HITACHI SERVICE BULLETIN

MODELS D-900

SUBJECT Improvement of PLAY operation

3. Illustration

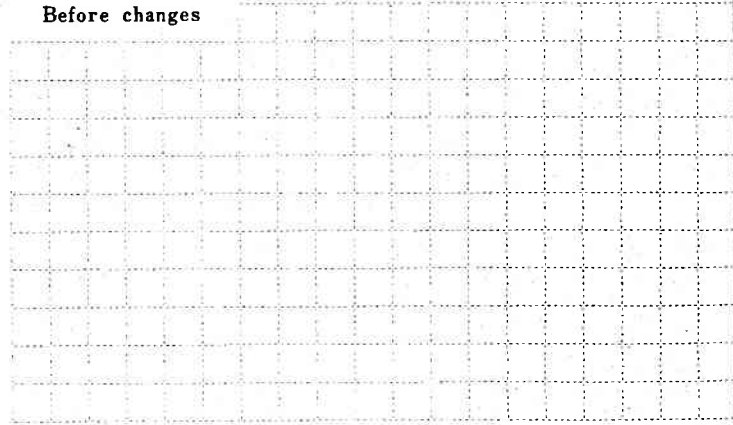
The capstan is short and there is danger of part of the pinch roller being deformed, so the length of the capstan has been lengthened by 1.5mm.

No.	Parts No.	Description	FOR ¥ Japan	*	Parts No.	Description	FOR ¥ Japan
	6373172	Flywheel(R)	340	$\overrightarrow{A B}$	6372609	Flywheel	
	6373194	Flywheel(L)	210	$\overrightarrow{A B}$	6372587	Flywheel	
				$\overleftarrow{A B}$			
				$\overleftarrow{A B}$

1). Crook AS spring as shown below.

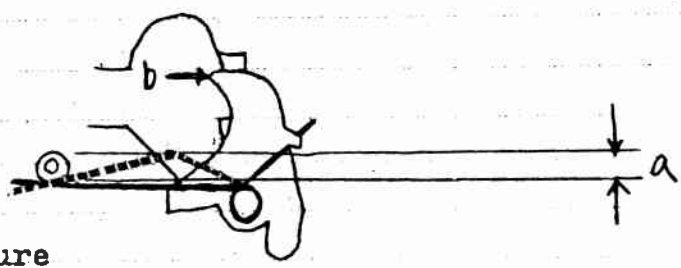
Mechanical sound occurs in SPOP mode, so to improve it, following modification has been made.

1. Crook AS spring as a dotted line.
Dimension of "a" is 1-2mm from AS control spring to intersecting point of AS control plate and chassis.
2. Then check the tension at point "b" with tension gage that AS control plate begin to start to rotate within 4-6 gram tension. If measured tension is not within 4-6 gram, readjust the crook of AS spring.
3. After assembling, turn on the power.
And confirm that abnormal sound doesn't produced on STOP mode.

2). Change of Take-up reel

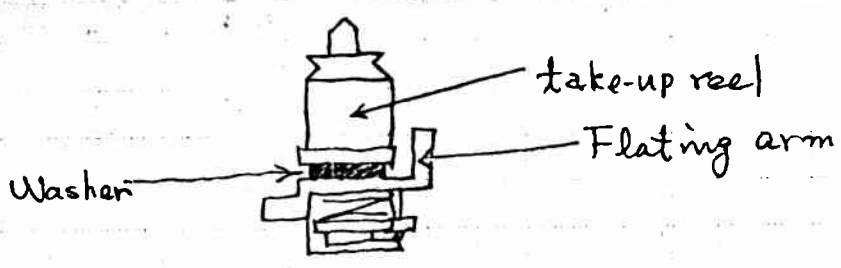
Addition of washer

3. Illustration

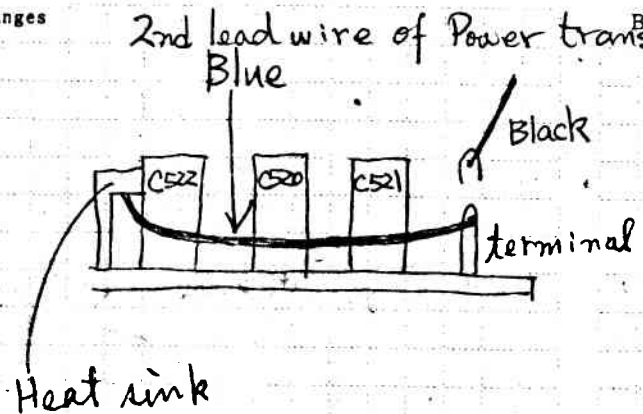
To decrease a hum noise, wiring of secondary wire (P.T) is changed.
 Wire "Blue" is paralleled with "Black" on original model. After changing, "black" is as in the original, and "Blue" is changed as below.

3. Illustration

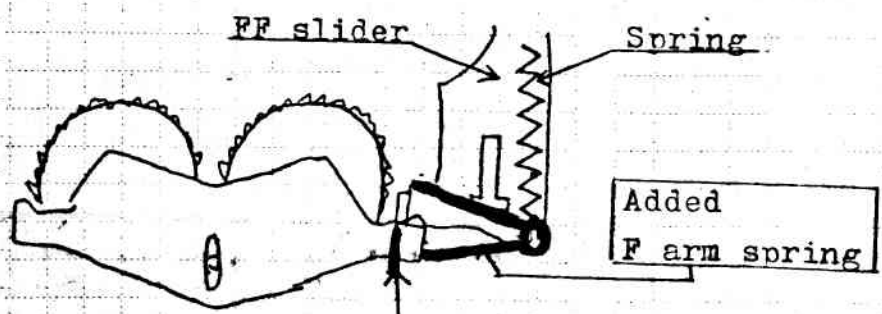
Mechanical gearing sound is produced from F gear of Gear plate, so to improve it, following modification has been made.

Lubricate "Hitazol" on this point

No.	Parts No.	Description	FOR ¥ Japan	*	Parts No.	Description	FOR ¥ Japan
	6308941	F arm spring	15.-	A B			
				A B			
				A B			
				A B

SUBJECT Improvement of auto stop mal-function

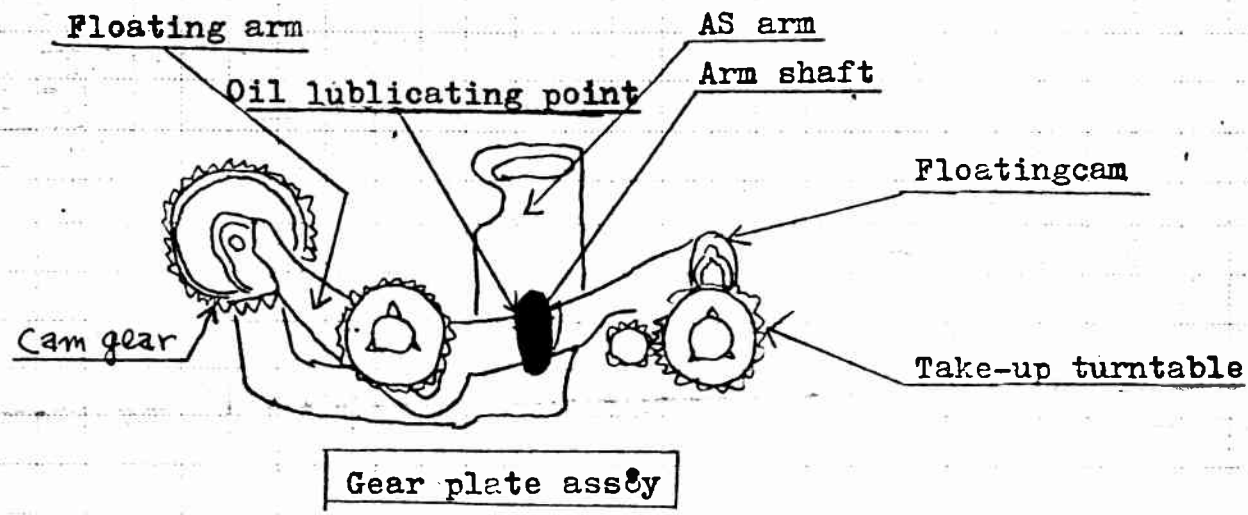
Tape transportation is stopped by working of auto stop mechanism on playing back mode, so to improve it, following modification has been made.

1. Remove Gear plate ass'y.
Lubricate Pan motor oil on the contact surface of Floating arm and Arm shaft and AS arm.
2. Make sure that AS arm moves smoothly.

After change,

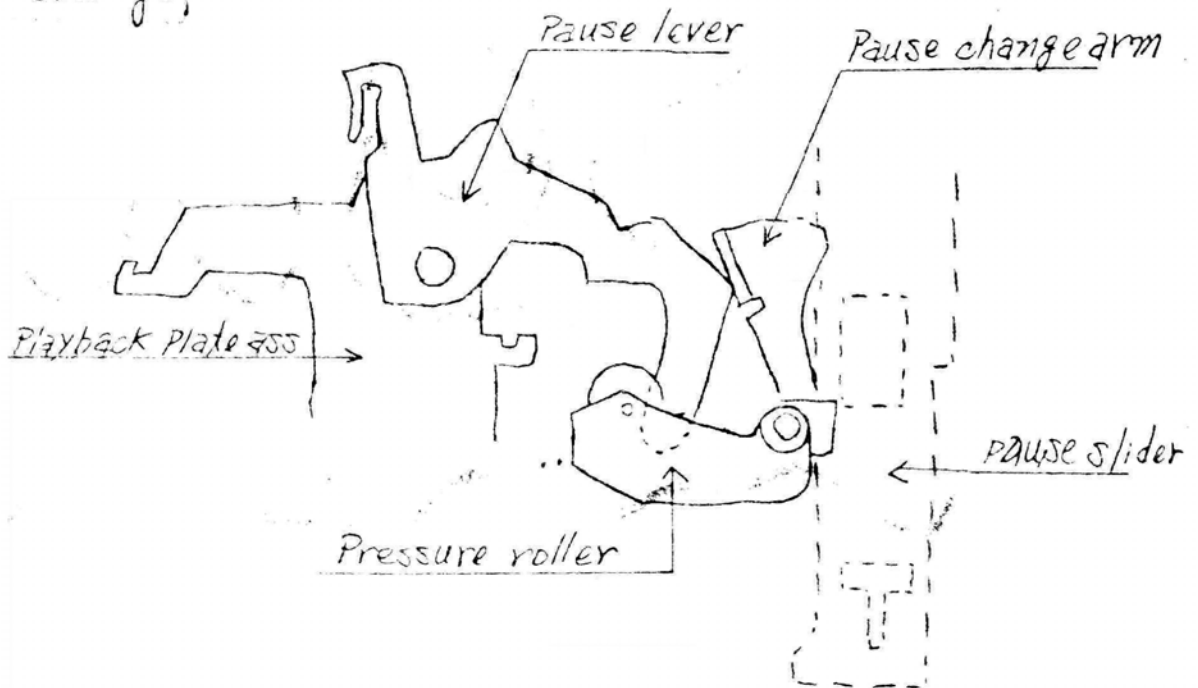
On former pause mechanism, when pause button depressed to stop the tape transportation temporarily during playing back or recording, heads and pressure roller return to original position. Therefore, it was caused by slow tape speed at beginning when pause mode is released.

- 1) Heads keep touch to tape surface.
- 2) Pressure roller detach from capstan.

Description	New parts	Original parts	Remarks
Pressure roller	6743589 50.-	6383154	D-550AU/RW/W/BS/FS
		6743587	D-550U SDT-7785B
		6383152	D-720all/SDT-9600
Pause lever	7305281 20.-	—	All
Pause change arm	7297225 20.-	—	All
Playback plate ass	7296068 60.-	7287038	D-550AU/RW/W/BS/FS
		7296065	D-550U SDT-7785B
		7287034	D-720U/AU/W/FS
		7287036	D-720C/RW
		7287032	SDT-9600
Pause slider	7287138 35.-	7287133	D-550AU/RW/W/BS/FS D-720ALL SDT-9600 SDT-7785B
